**TO: PLANNING COMMISSION**

**SUBJECT: DESIGN REVIEW – SITE PLAN REVIEW – ADJUSTMENT CASE NO.  
19-10; 990 BROADWAY STREET NE - 97301  
AMANDA NOS. 19-114686-DR, 19-114687-RP, AND 19-114688-ZO**

Summary: Proposed three story mixed-use multi-family and retail development on a vacant portion of the site, and maintaining an existing parking lot and driveways.

**1 TRASH ENCLOSURE**  
SCALE: 1/4" = 1'-0"

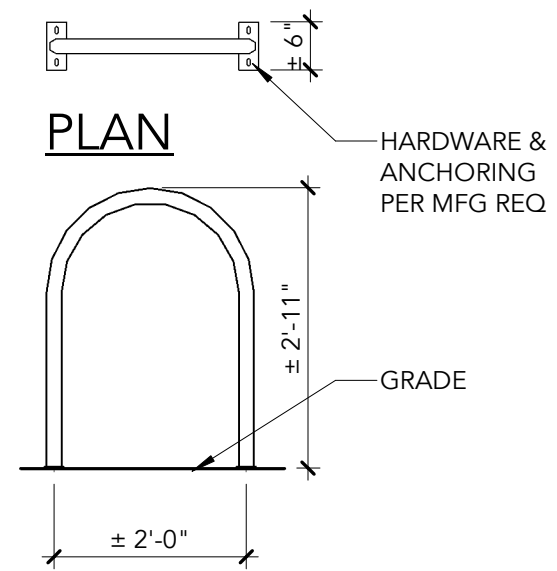
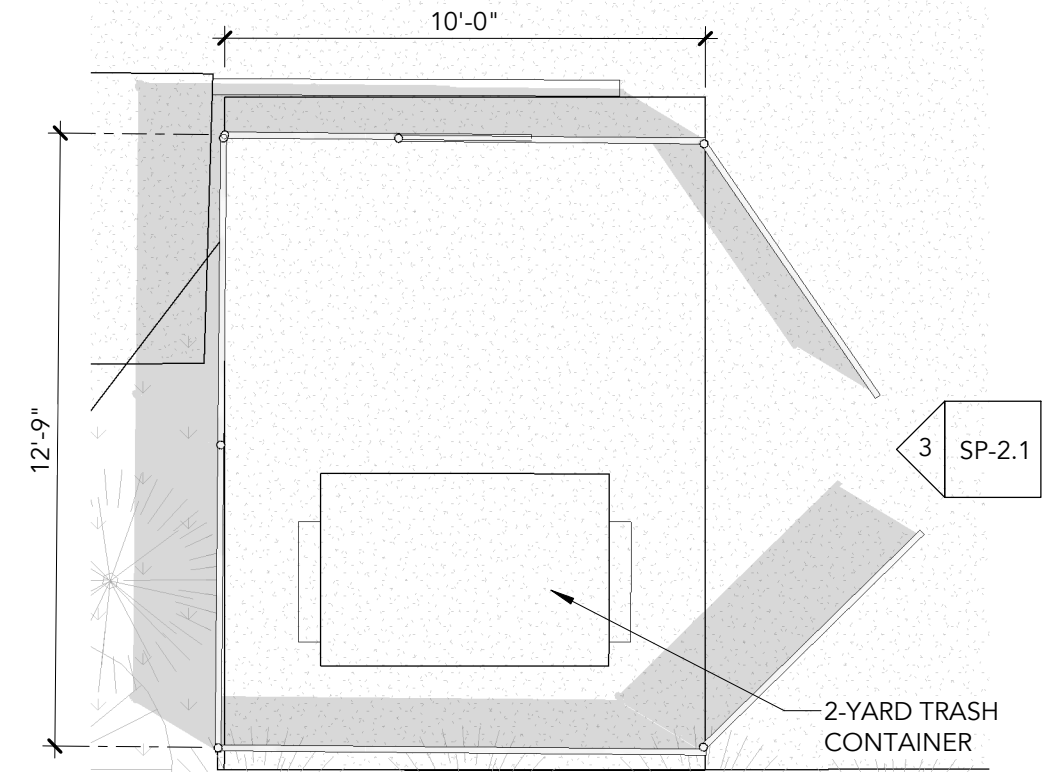
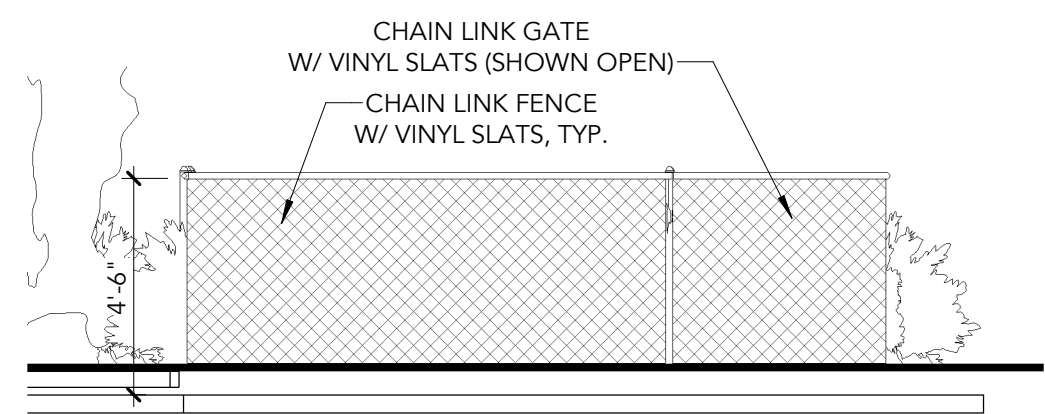
**Finding:** The site plan indicates that a new solid waste enclosure with receptacles 2 cubic yards in size is proposed.

**Finding:** The proposed site plan indicates that the enclosure walls will be chainlink with privacy slats. A bumper curb 12 inches inside the perimeter of the enclosure walls is required, however the curb is not indicated on the proposed plans.

- Condition 1:** Development of the solid waste service area shall conform to all applicable standards of SRC Chapter 800.
- Condition 2:** Obtain awning permits for proposed awnings encroaching into the right-of-way.

GRADING & UTILITY PLAN

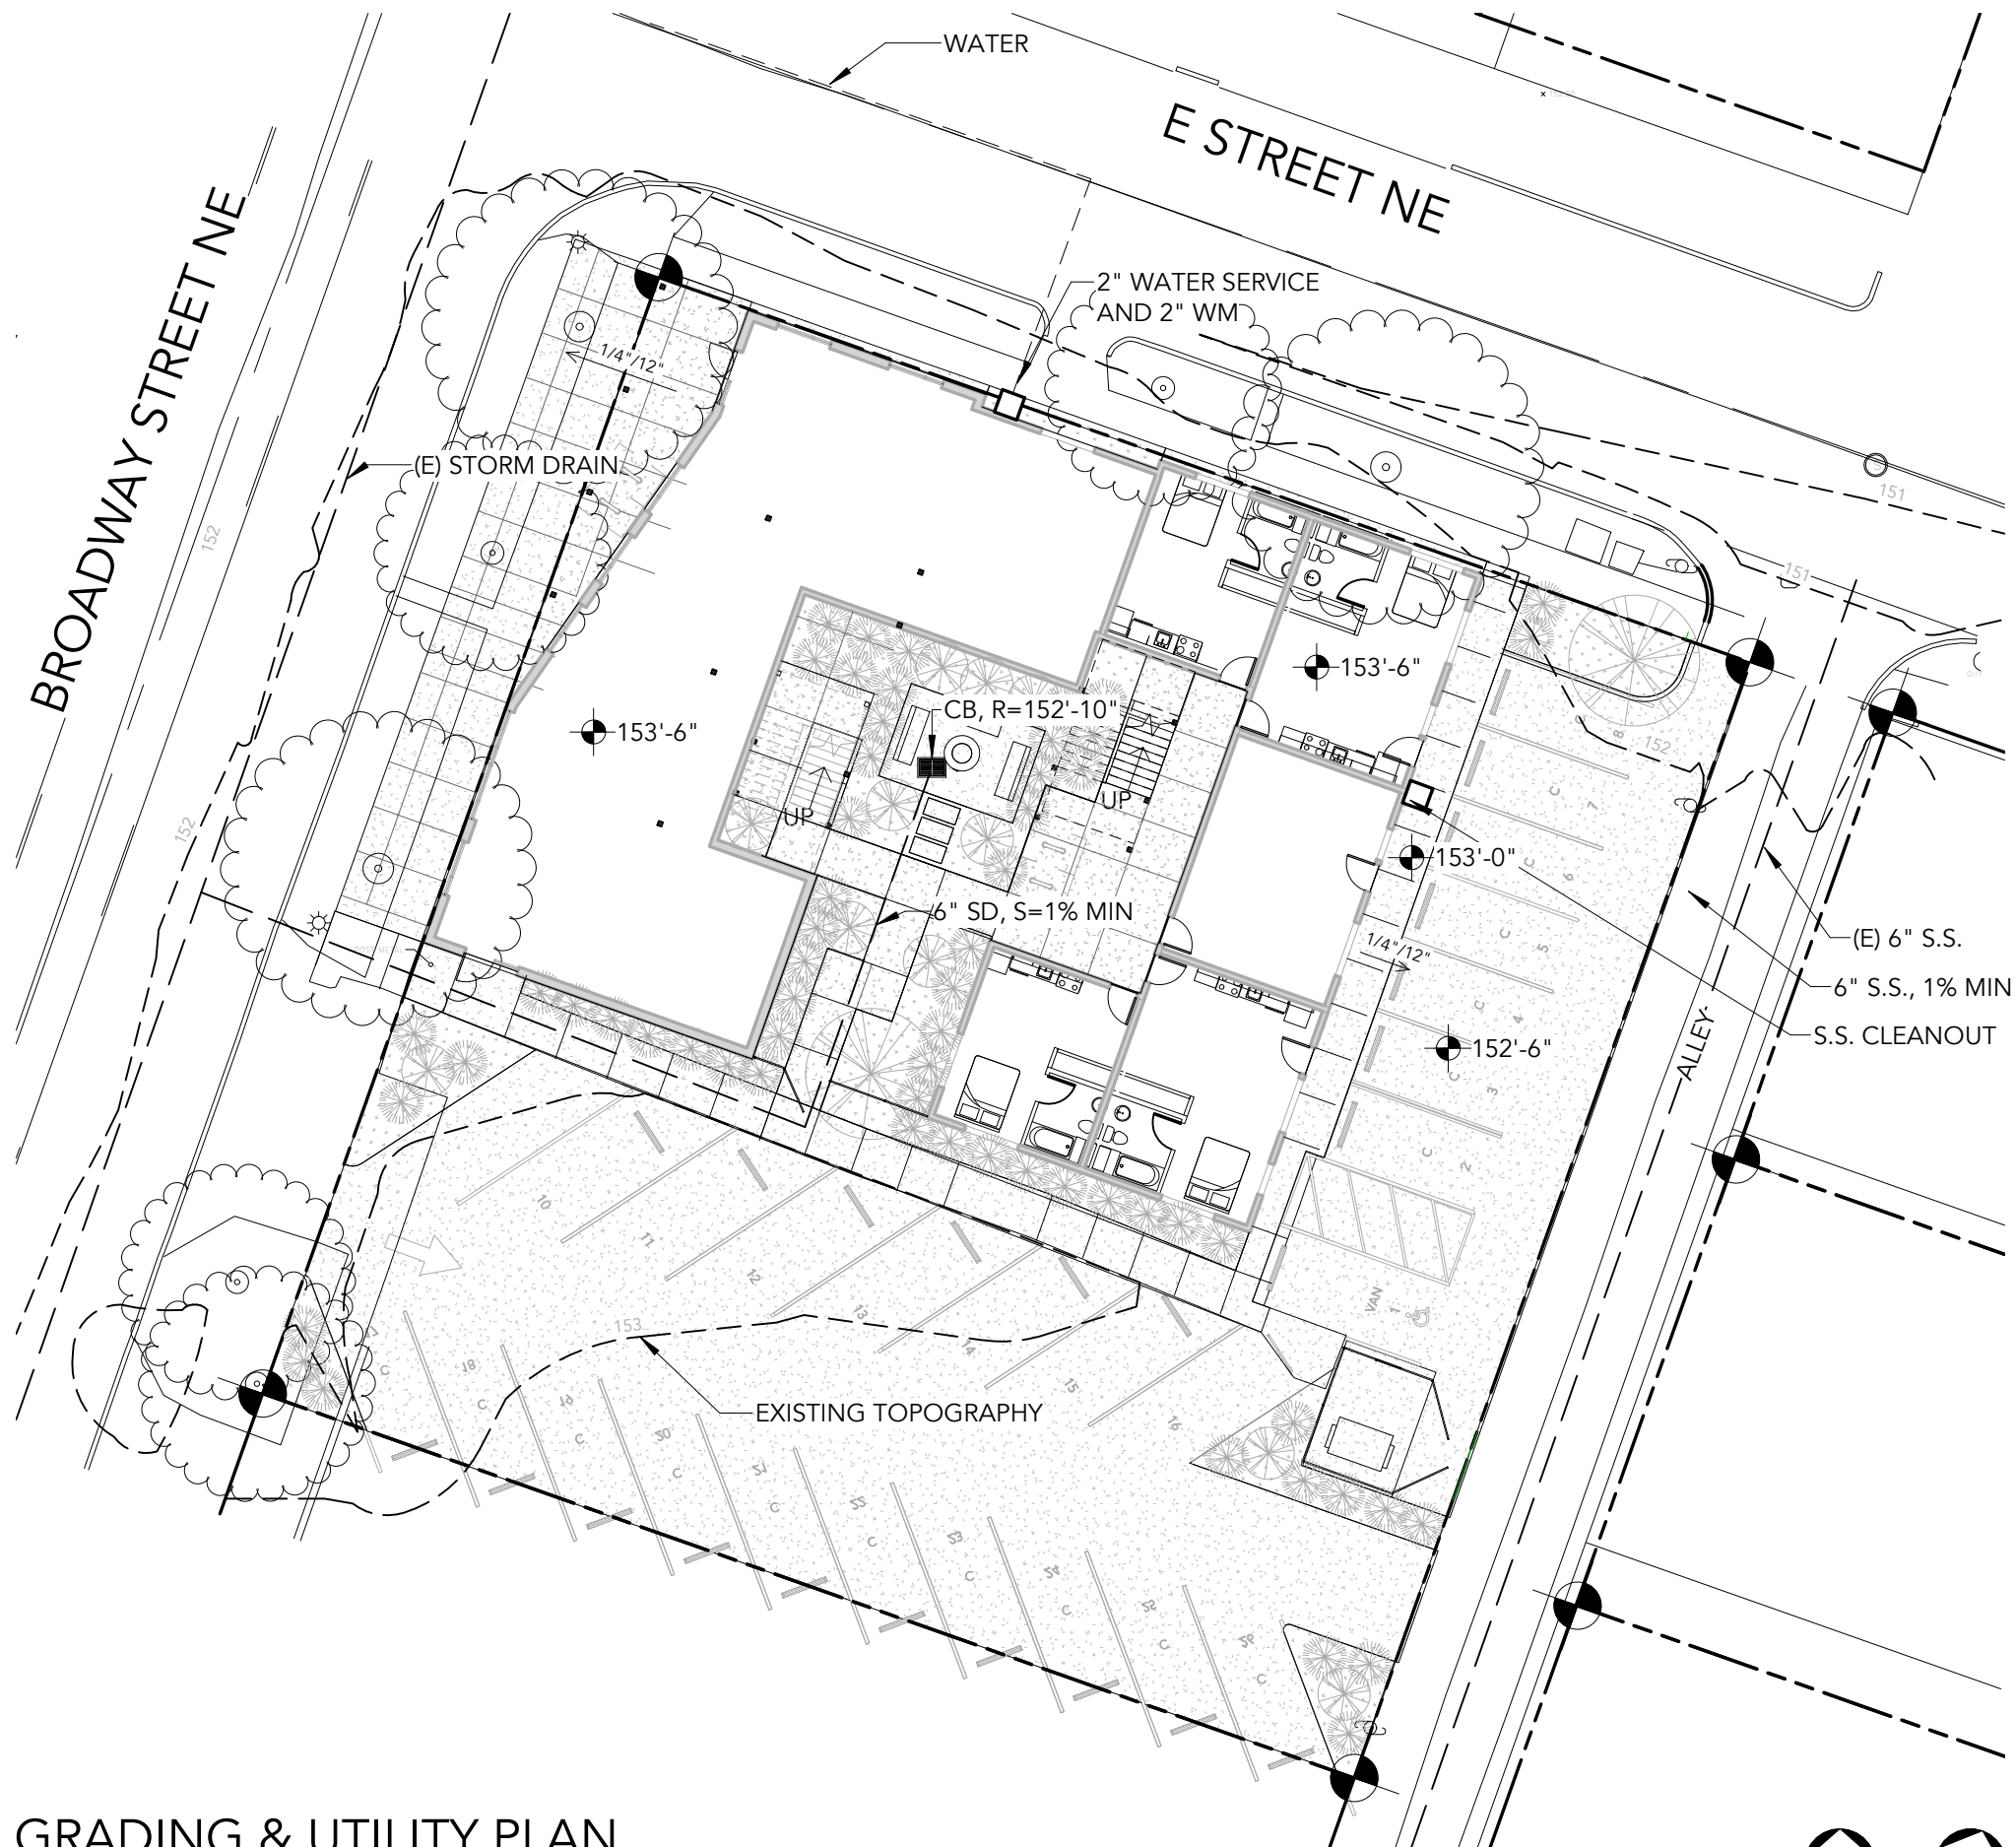
**Finding:** The Public Works Department has reviewed the applicant's preliminary plan for this site. The water, sewer, and storm infrastructure are available within surrounding streets/areas and are adequate to serve the proposed development.

The applicant shall be required to design and construct a storm drainage system at the time of development. The application shall provide an evaluation of the connection to the approved point of discharge for new areas of impervious surface per SRC 71.075. The applicant's architect submitted a statement demonstrating compliance with SRC Chapter 71 because the project involves less than 10,000 square feet of new or replaced impervious surface.

LANDSCAPE PLAN

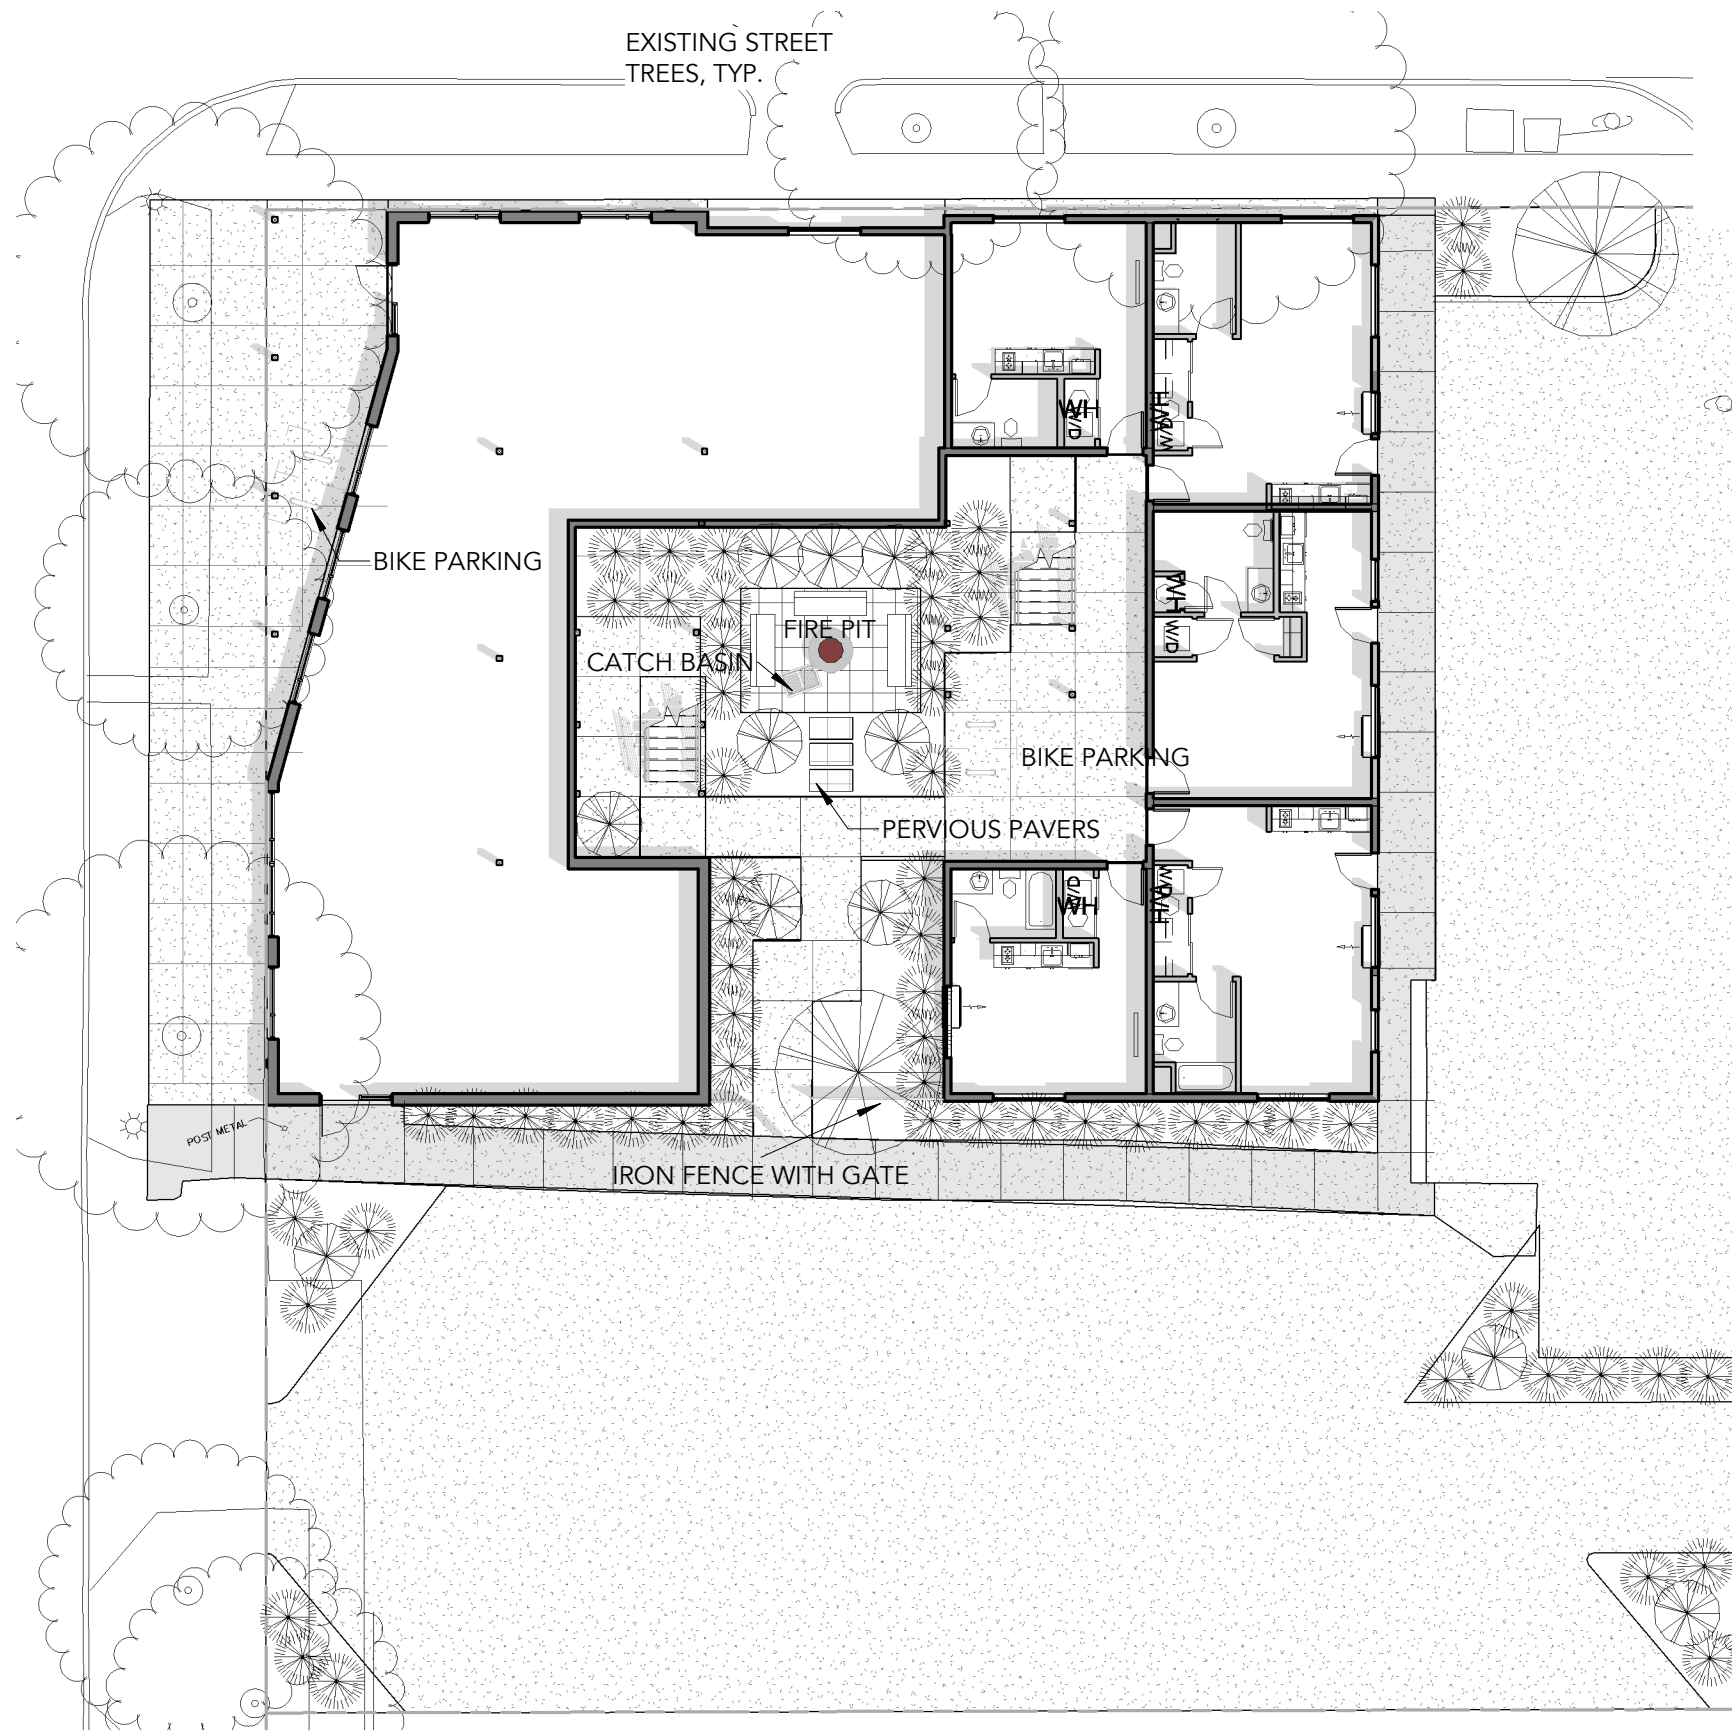
**Finding:** The proposed site plan indicates that approximately 1,774 square feet of landscaping is provided for the development site. However, as conditioned a minimum of 115 plant units are required for the proposed development. Of the required plant units, a minimum of 46 plant units shall be a combination of mature trees, shade tree, evergreen/conifer trees, or ornamental trees ( $115 \times 0.4 = 46$ ).

**Condition 8:** A minimum of 115 plant units shall be incorporated into the landscape design.
